AGENDA
VILLAGE BOARD MEETING
Tuesday, December 8, 2020 at 7:30 p.m.
Jackson Village Hall
N168 W20733 Main Street
Jackson, WI 53037

SECTION 00 63 63 CHANGE ORDER

Change Order No. 4

**VILLAGE OF JACKSON
MUNICIPAL COMPLEX**

VILLAGE OF JACKSON
LOT 2 & LOT 3 DITCHING
WASHINGTON COUNTY, WISCONSIN
DITCH PLAN AND PROFILE

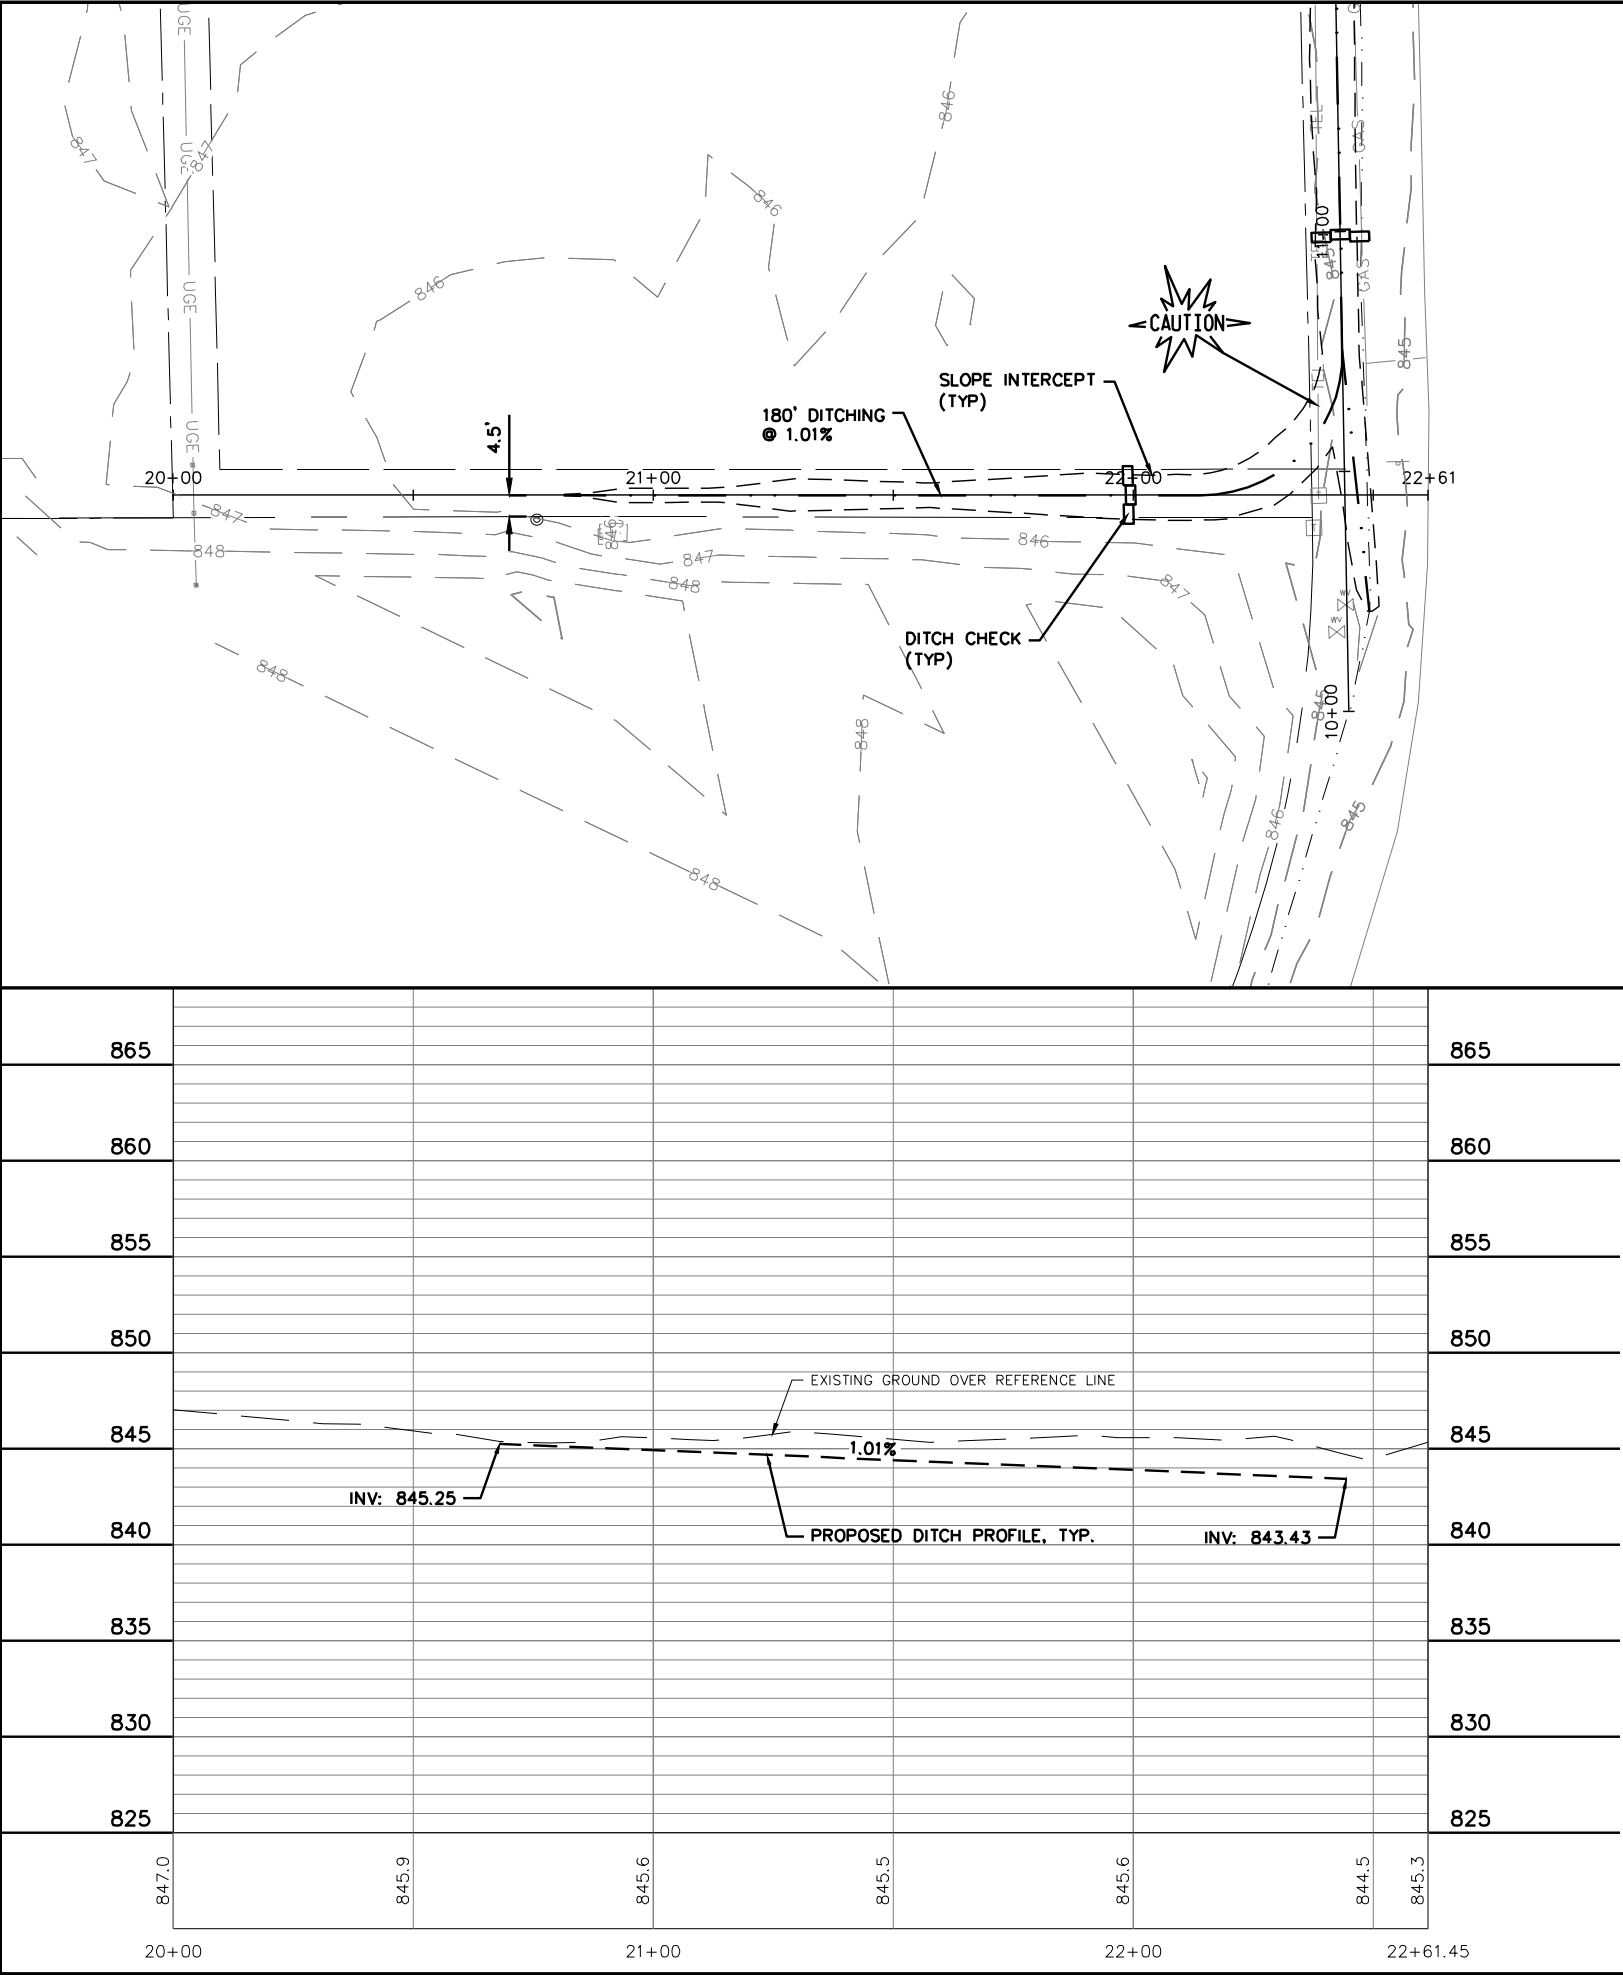
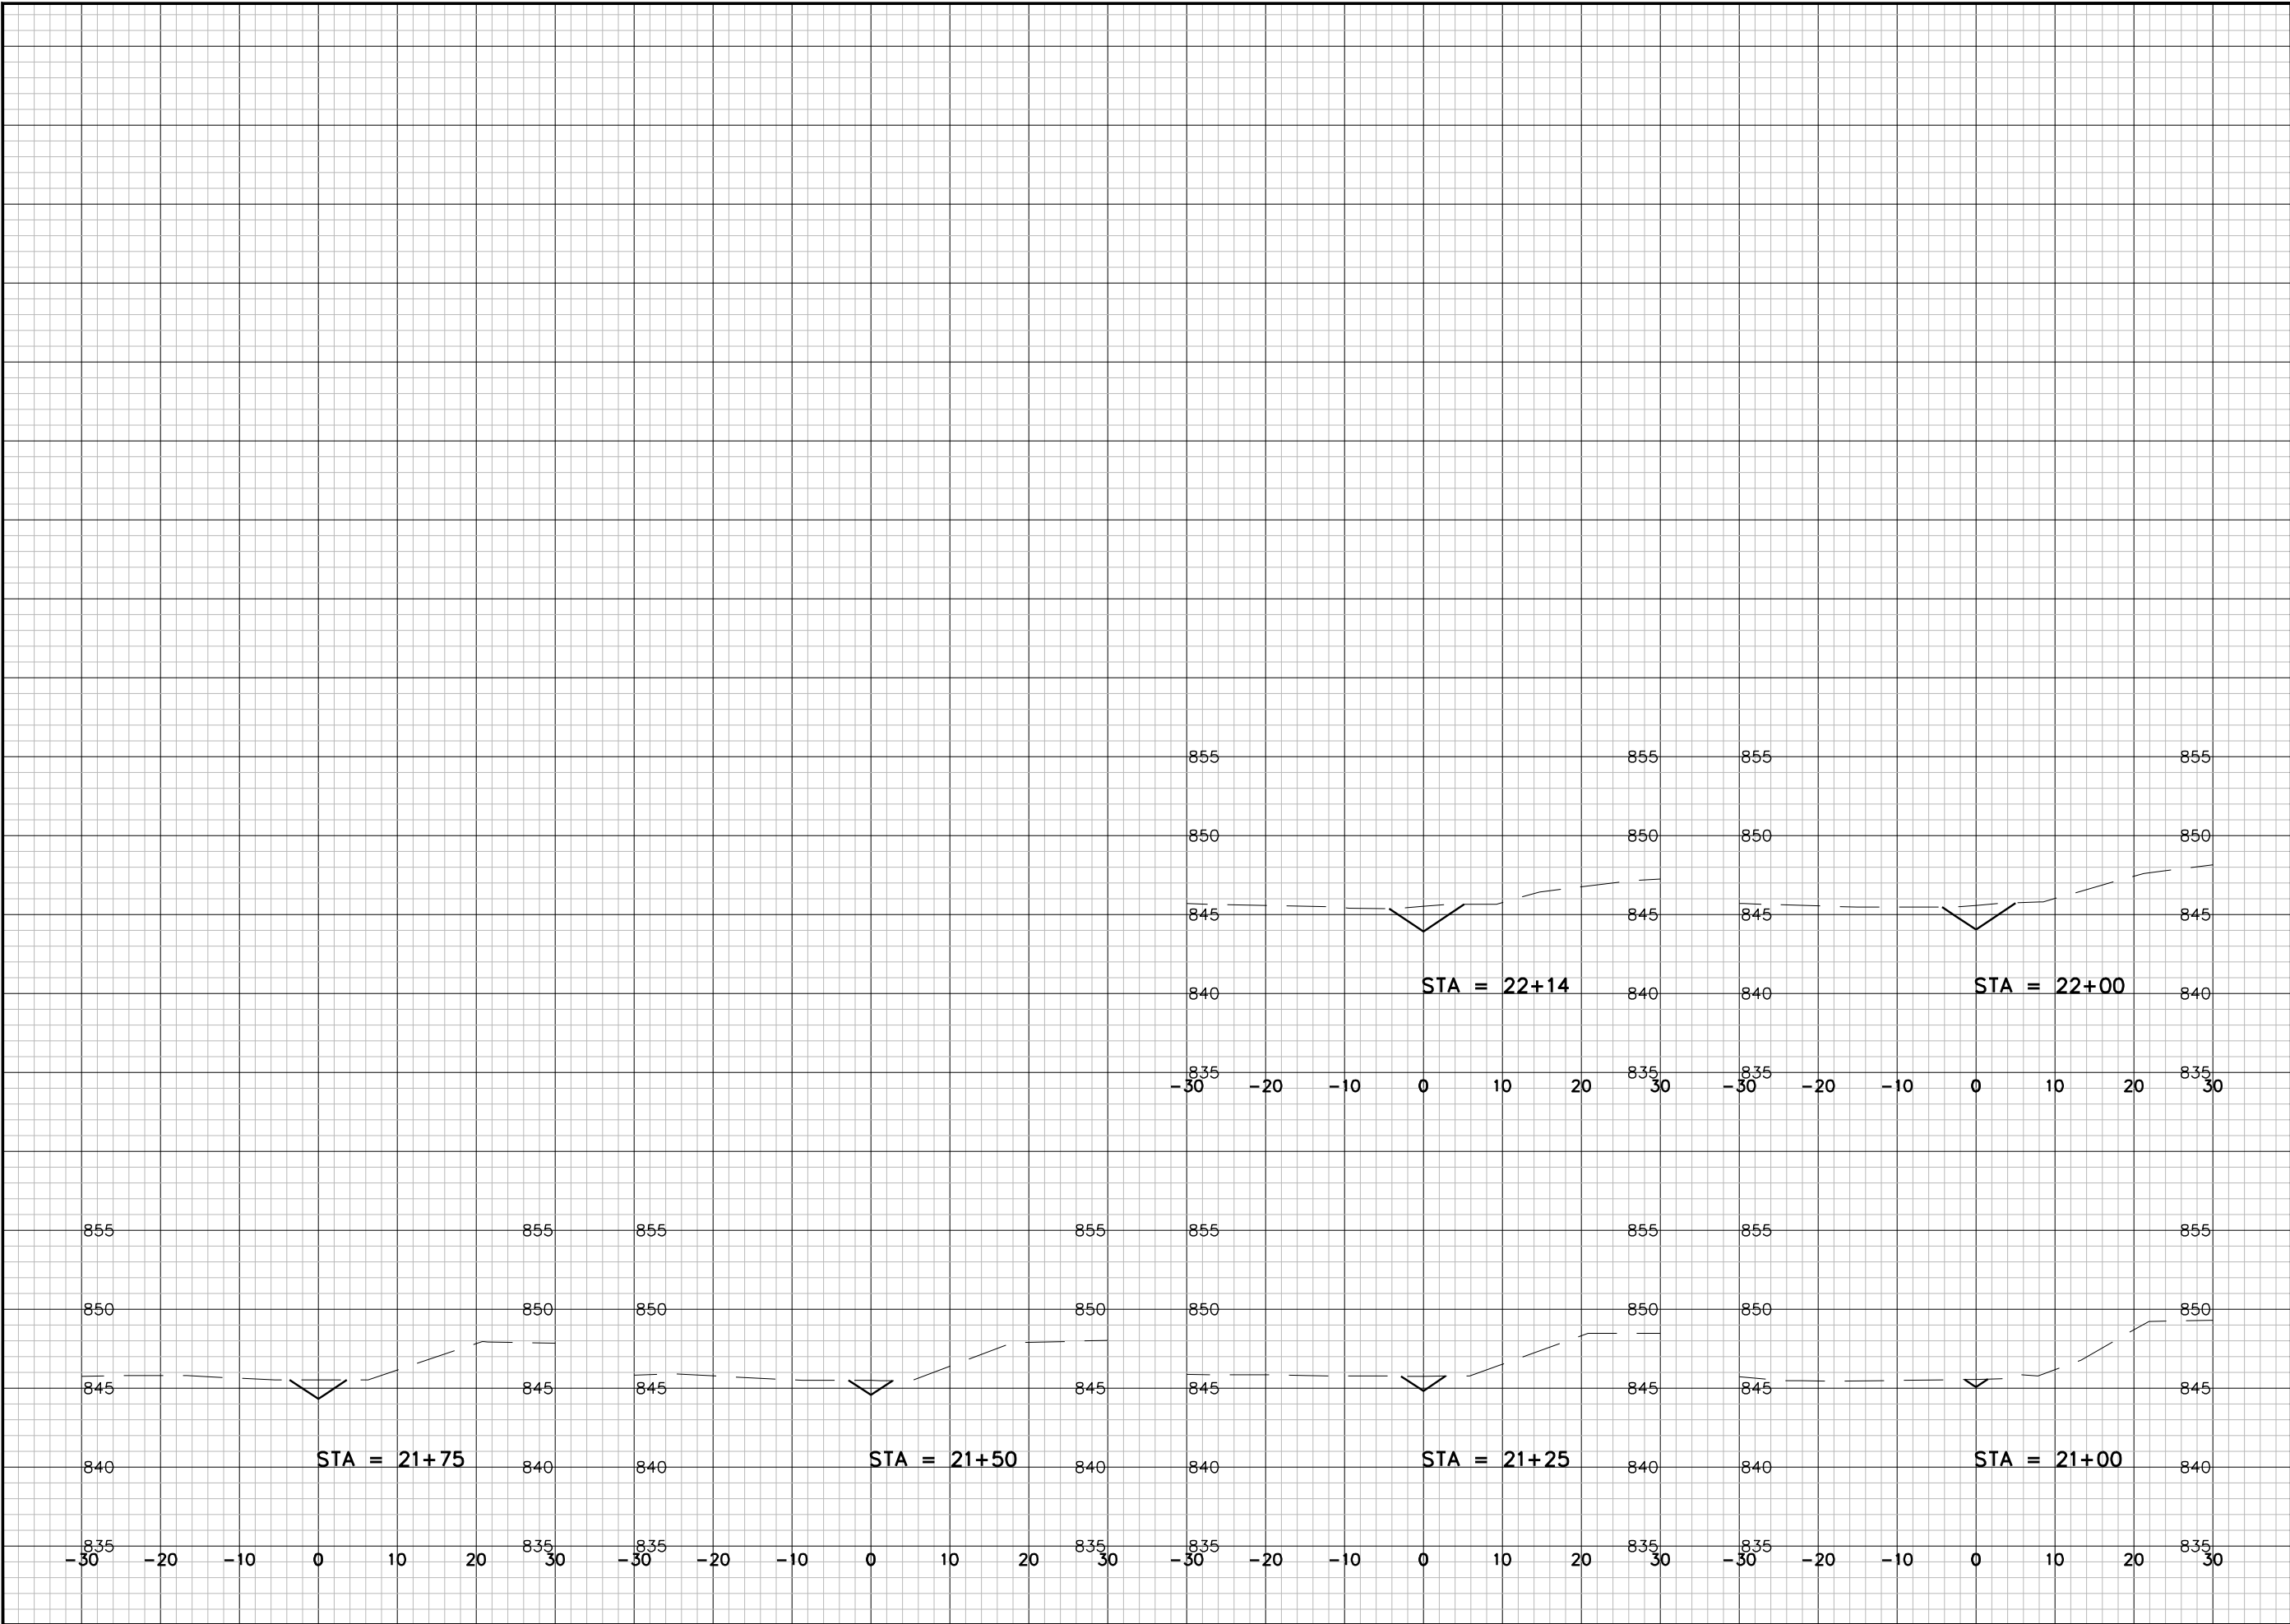
- Cost Proposal: Lower 18" Storm Sewer/AEW, SW Corner of Eagle Dr & Spruce St. (2020) – LUMP SUM (See Attached Plan Sheet 1 of 4) **\$2,700 Lump Sum**
- Cost Proposal: Ditching & Restoration – "Lot 2 & 3 Ditching" (2021) – LUMP SUM (See Attached Plan) **\$3,400 Lump Sum. Spoils to be spread on lot adjacent to ditch.**
- Cost Proposal: Clearing/Grubbing and Ditching – Approx. 250' +/- East of Eagle Drive – LUMP SUM (Coordinate w/ Owner) **\$3,600 Lump Sum. Clearing/Chipping of trees by Village.**

Yes all cost are acceptable.
